ADDENDUM NO. 1

Plans & Specifications for: Cedarwood Playground, Waltham, MA

In accordance with documents prepared by: Carolyn Cooney & Associates

This Addendum No. 1 is to modify, correct and/or supplement the Plans and Specifications.

Drawing Title REVISION TO WELCOME SIGN HEIGHT (2 REQUIRED)

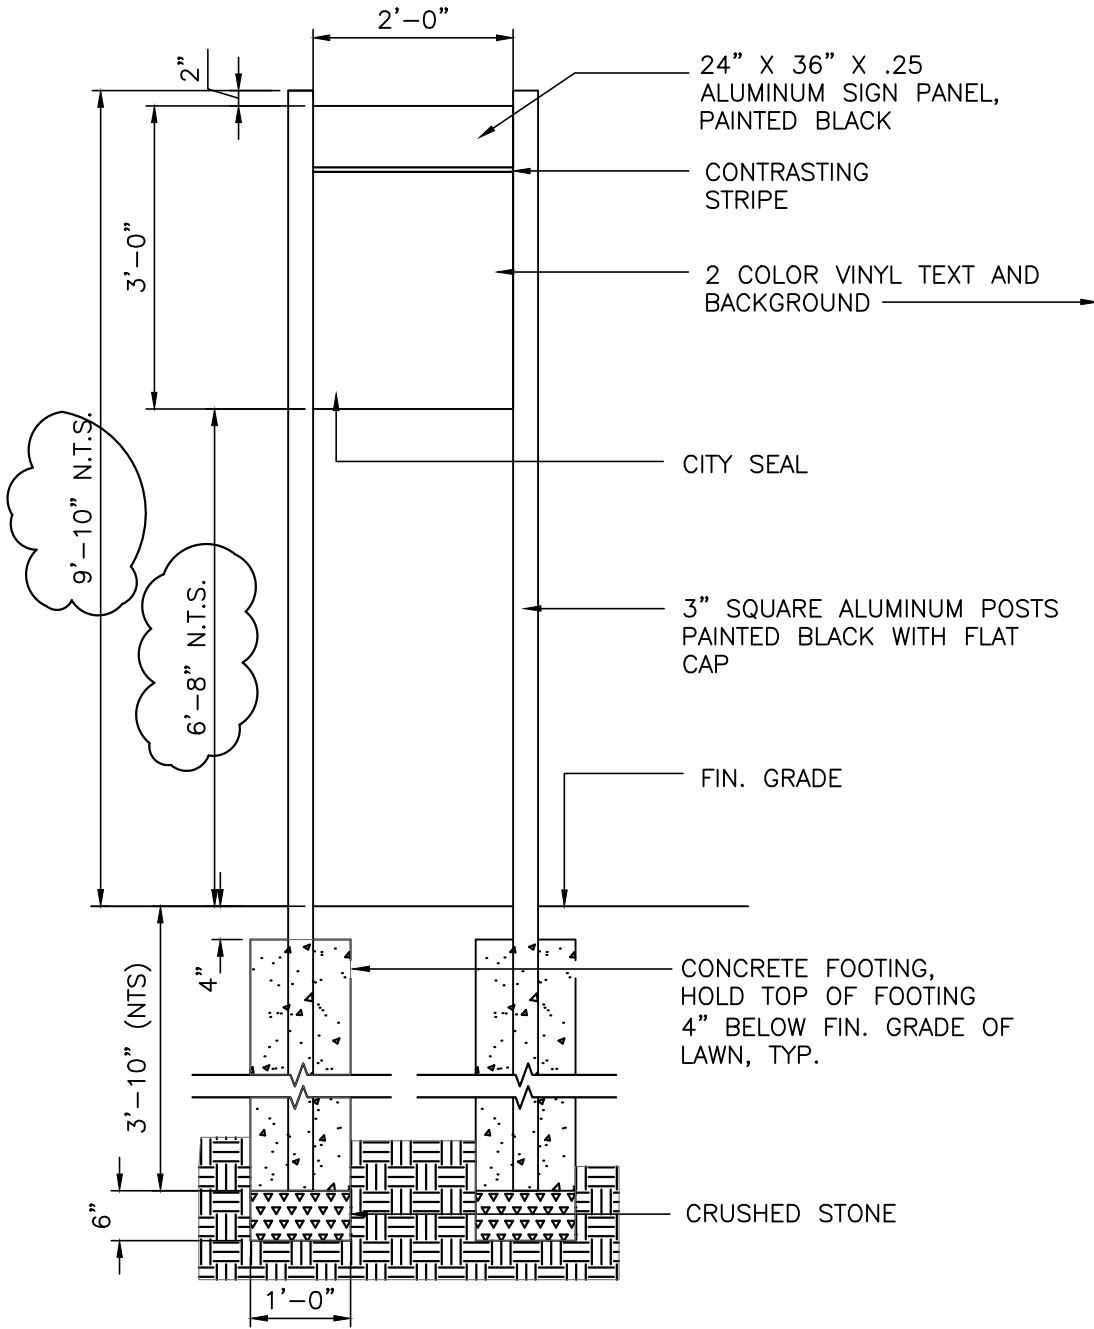
- 1) **SKL-1 Revision to Welcome Sign Height**
- 2) **SKL-2 Relocation of Steel Service Gate, Provision of Pedestrian Walk-around**
- 3) **Revised Form for General Bid to include allowances**

LOCATION OF SIGNS REQUIRE APPROVAL IN THE FIELD BY THE LANDSCAPE ARCHITECT PRIOR TO INSTALLATION
